Keri Keri Wind Farm – Response to Submissions (TfNSW)

Amber Organisation has been engaged to assist with response to agency advice received from Transport for NSW (dated 11 March 2026) related to Keri Keri Wind Farm. Table 1 provides a summary of the comments which have been addressed herein.

Table 1: TfNSW Response to Submissions

Figure 1: OSOM Passing Manoeuvre - Swept Path

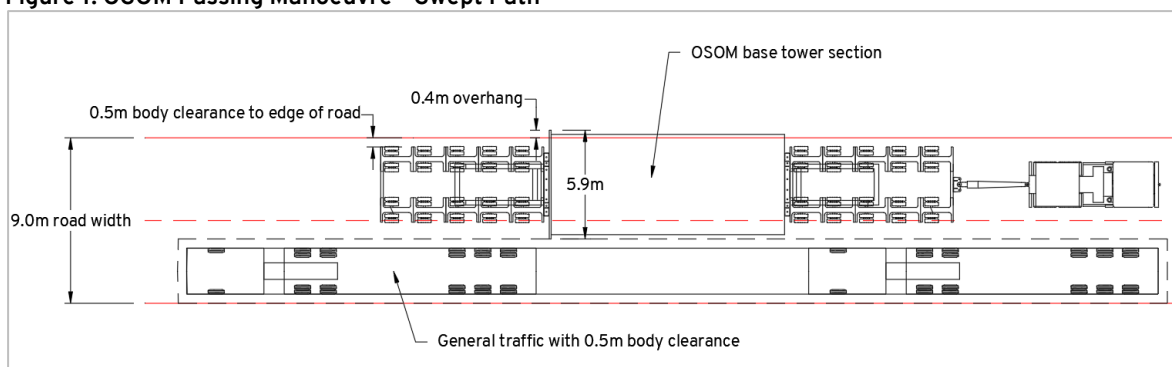
It is considered that a minimum clear width of 3.5m would be suitable to allow for general traffic including a typical 2.5m wide heavy vehicle configuration (e.g. B-double or Road Train) to comfortably pass the OSOM loads with 500mm clearance on either side of the vehicle body. A swept path assessment is provided in Figure 1 for the passing manoeuvres reflecting the base tower section which forms the widest load width at 5.9m (maximum flange width).

The assessment indicates a minimum road width of 9.0m is sufficient to allow for passing manoeuvres with the aforementioned 0.5m body clearances. The OSOM base tower section would overhang the edge of the road by up to 0.4m during passing manoeuvres which is acceptable as roadside assets are generally set back further from the road edge, and the base tower section would overhang any adjacent guardrails due to its circular shape. Reduced vehicle clearances could also be managed for slow speed passing manoeuvres where guardrails are situated immediately adjacent to the roadway, for example at the Sturt Highway bridge over the Murrumbidgee River.

Keri Keri Wind Farm - OSOM Routes 1A/1B
 KM Index 2.7: Sturt Highway / Murray Valley Highway, Euston
 Strategic Concept Design

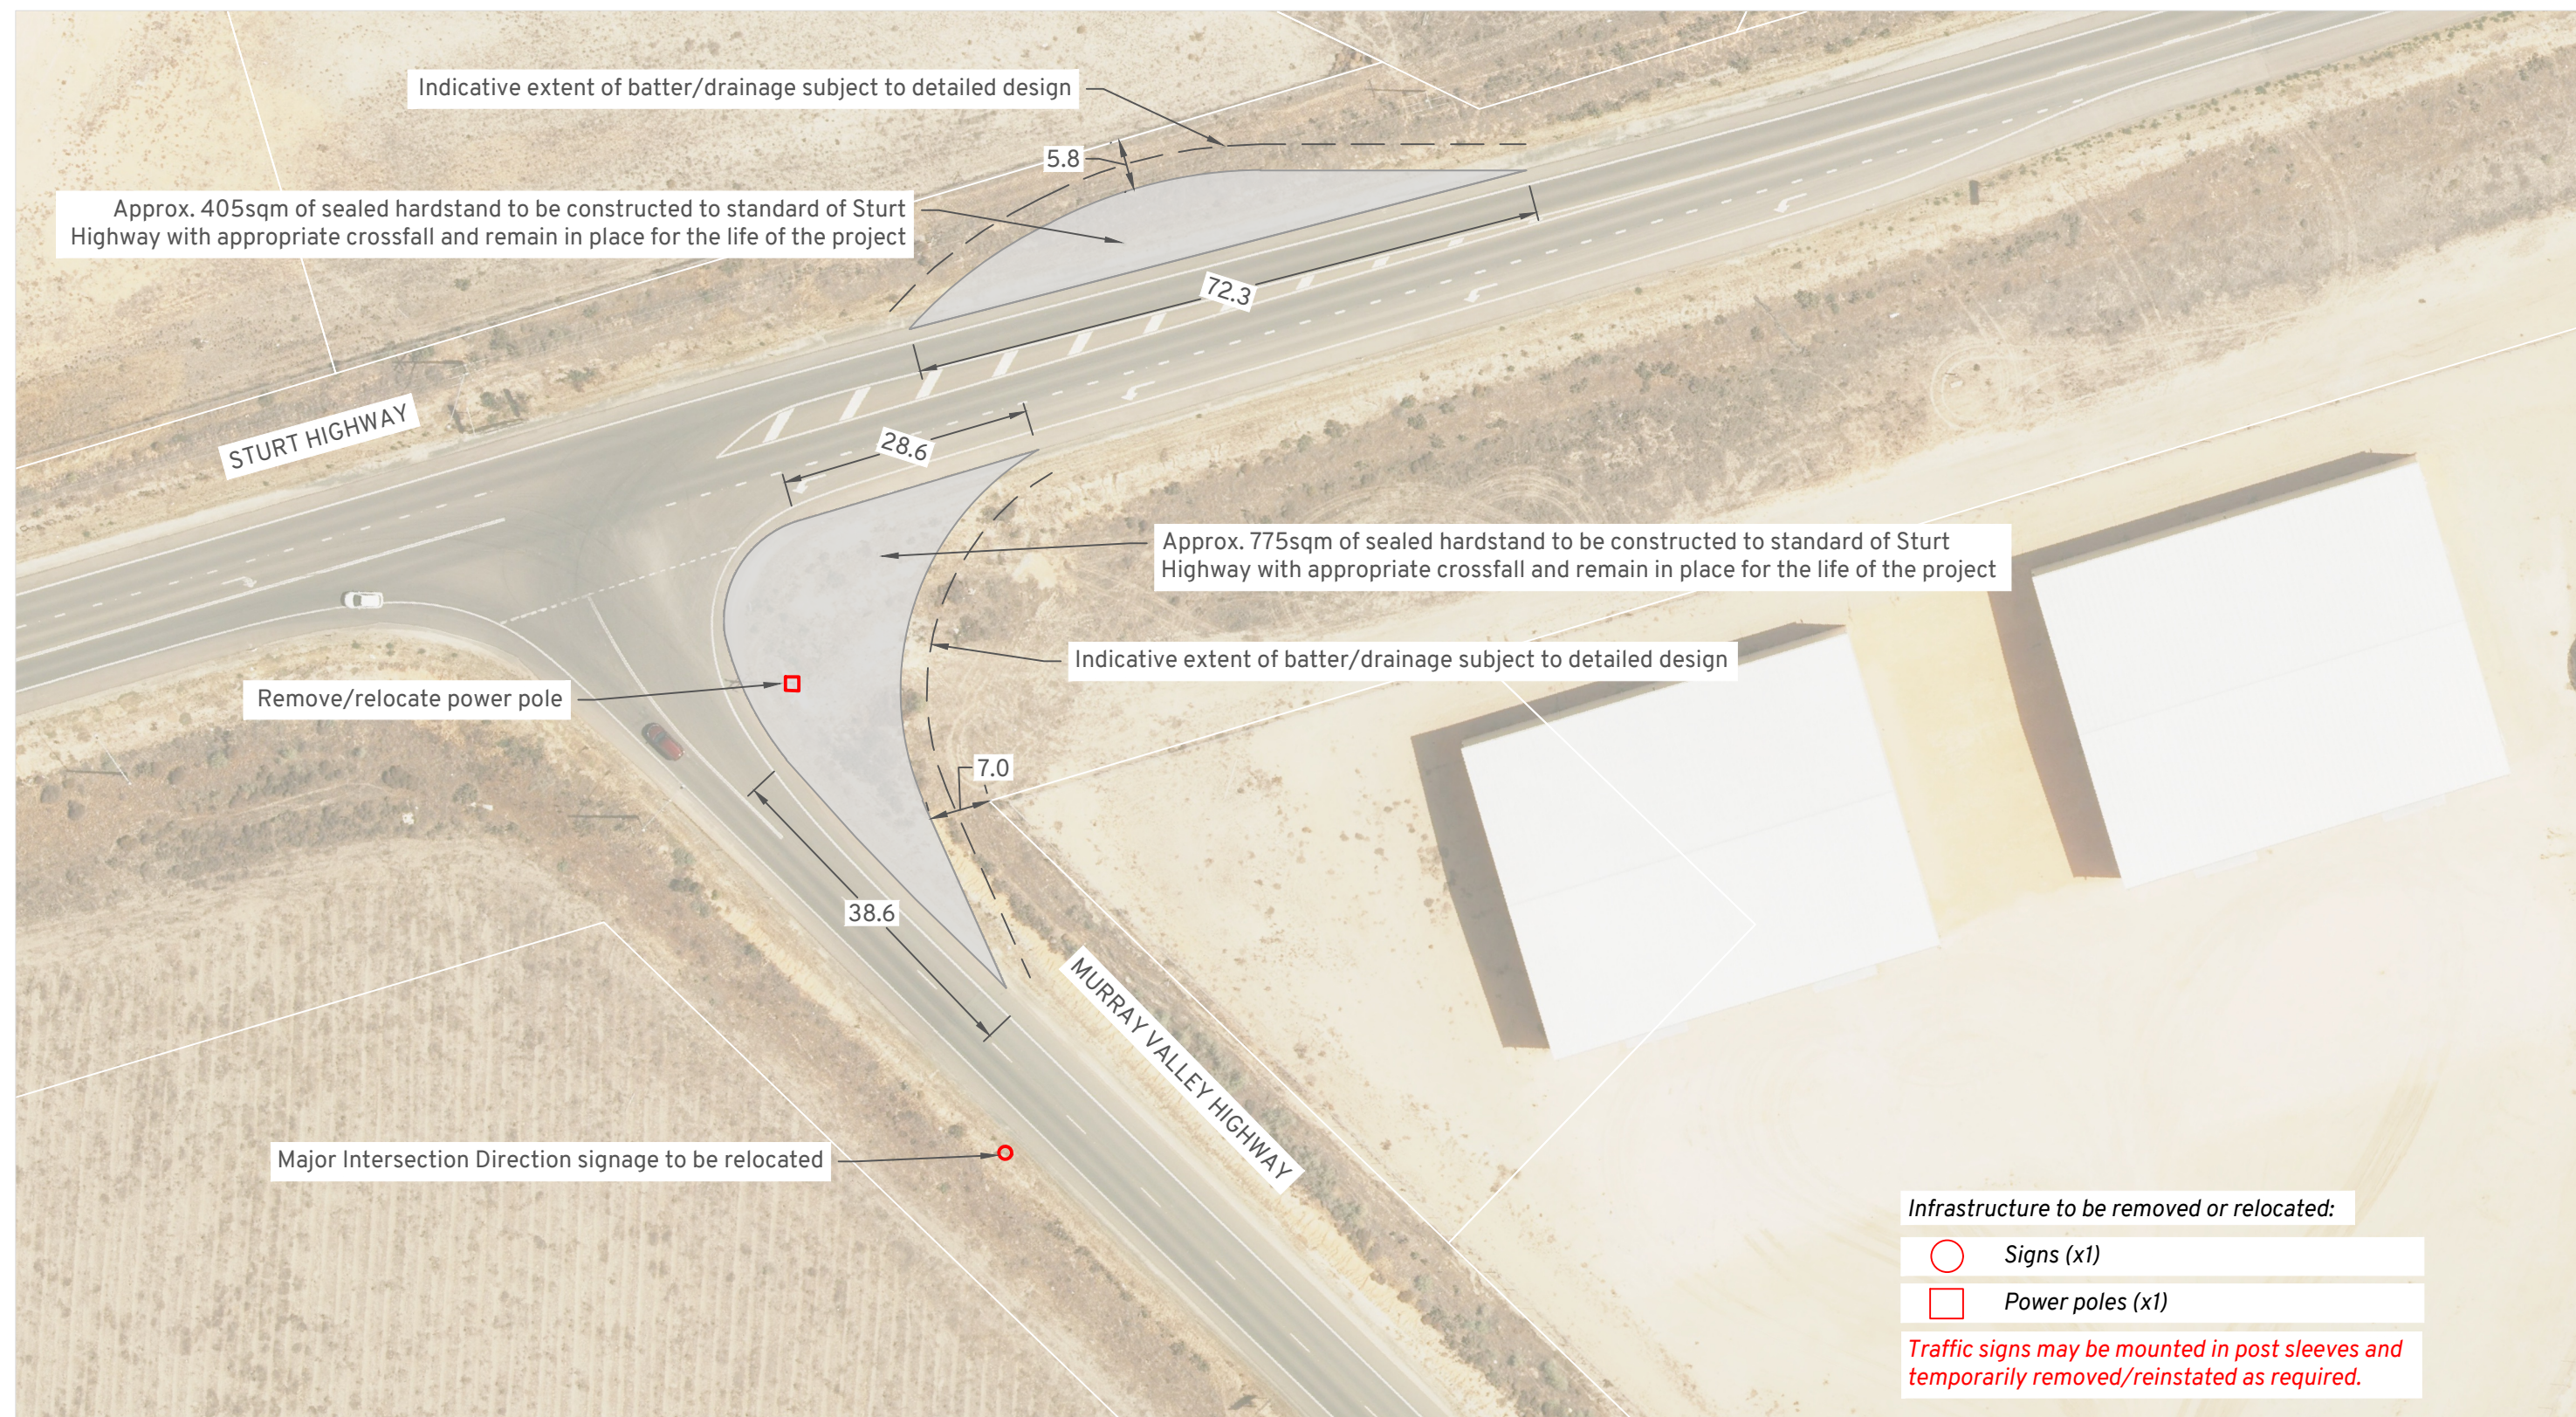
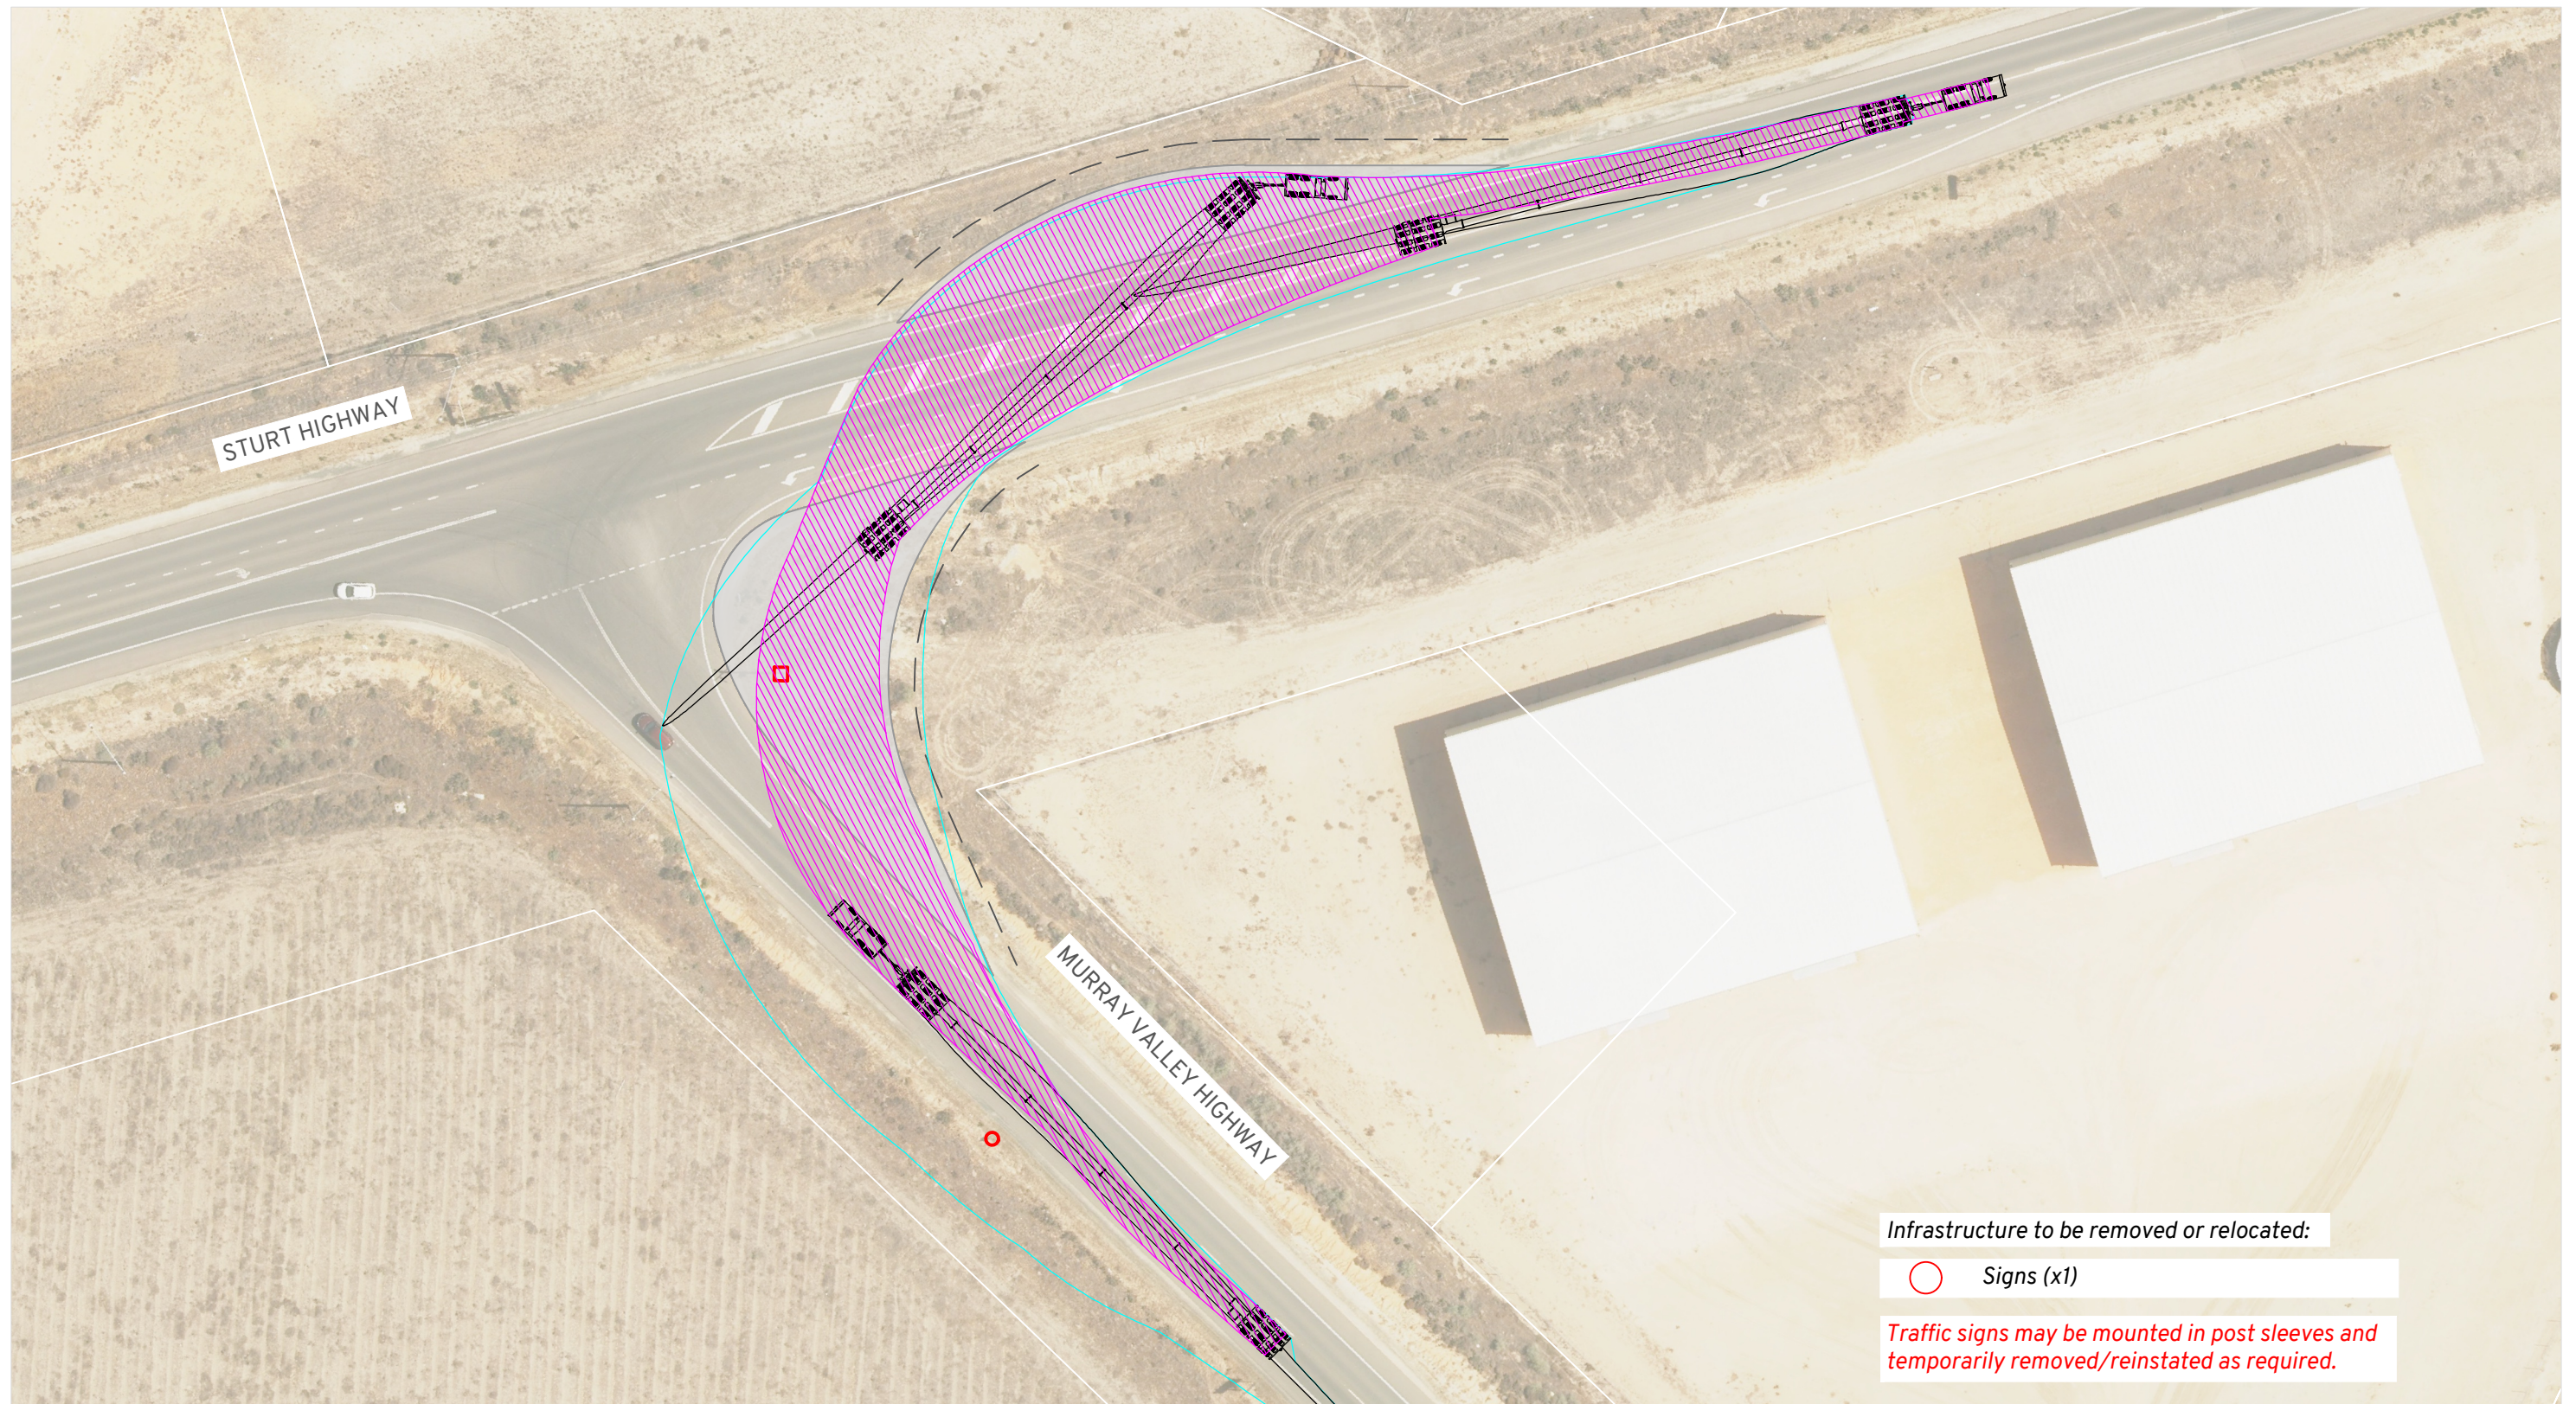
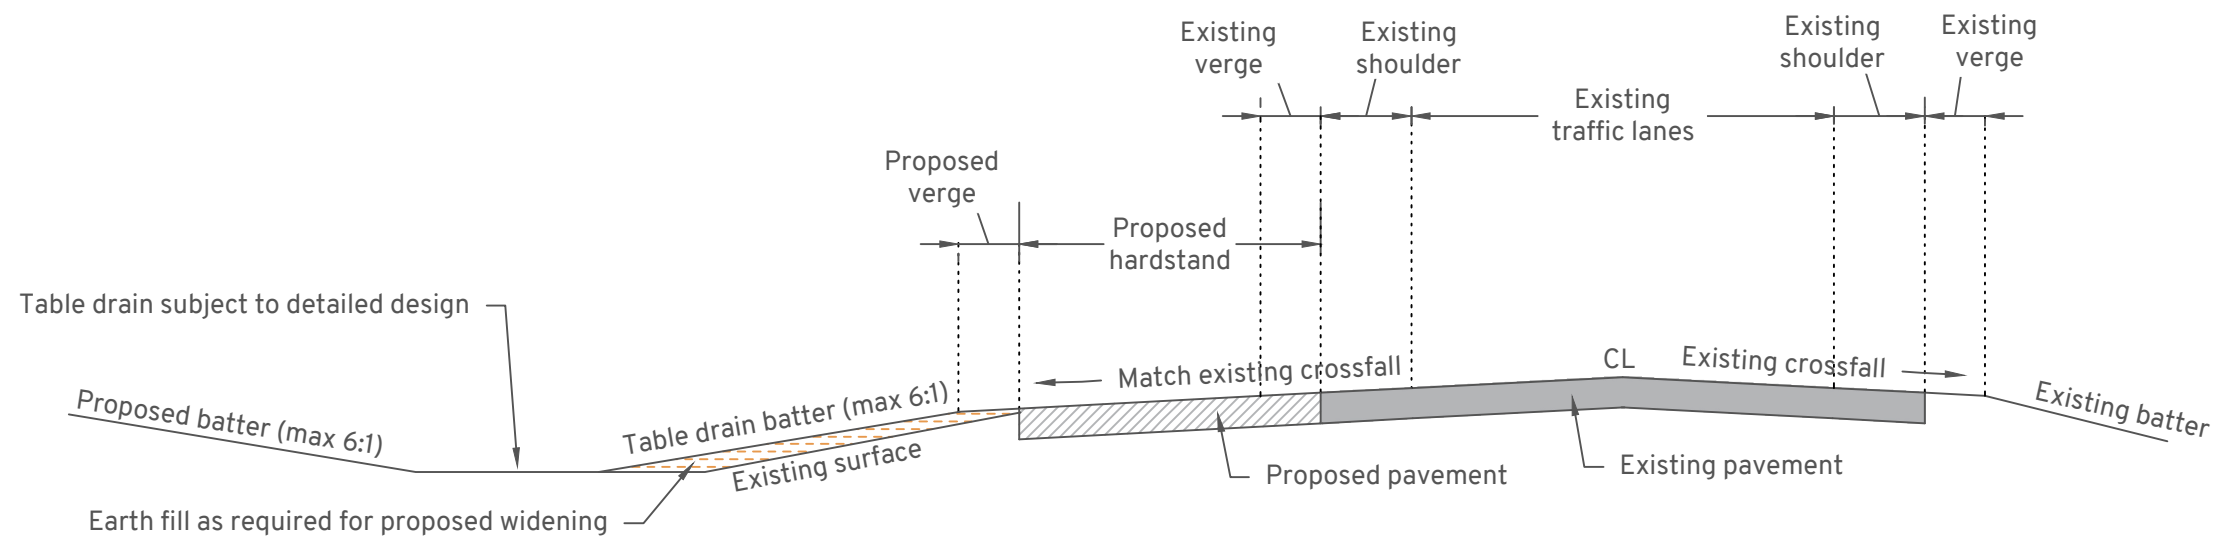
Ref.	TfNSW Comment	Response
3a/b	Strategic Concept Design Amendment <u>a. Revision D civil Design, RJ Andrews SPA - Murray Valley Hwy onto Sturt Highway</u> - The existing fill embankment is high, with swept paths showing to track close to cadastre boundaries. Hardstand areas will need to be quantified to determine the scope and footprint of the fill required for the embankment and to confirm whether land acquisition is required. <u>b. Revision D Civil Design, RJ Andrews SPA - Murray Valley Hwy onto Sturt Highway</u> - There appear to be numerous underground utilities located on the south-east corner of the intersection. Further investigation required to determine the level of impact.	Refer comment 3i.
3c/d	<u>c. Revision D, Civil Design, RJ Andrews SPA - Sturt Highway at Balranald</u> - TfNSW preference is to maintain the current intersection configuration with medians and kerb and channel. Revised strategic concept designs required that references to the barrier kerb be removed and replaced with a roll-over kerb to facilitate movements onto the hardstand. <u>d. Drainage pits</u> will need to be assessed and made trafficable as required. To be annotated on the strategic concept designs.	Revised strategic concept design for this intersection is provided in Appendix A (Sheets 04-07). The design includes a dish crossing with trafficable grates to facilitate movements onto the hardstand area.
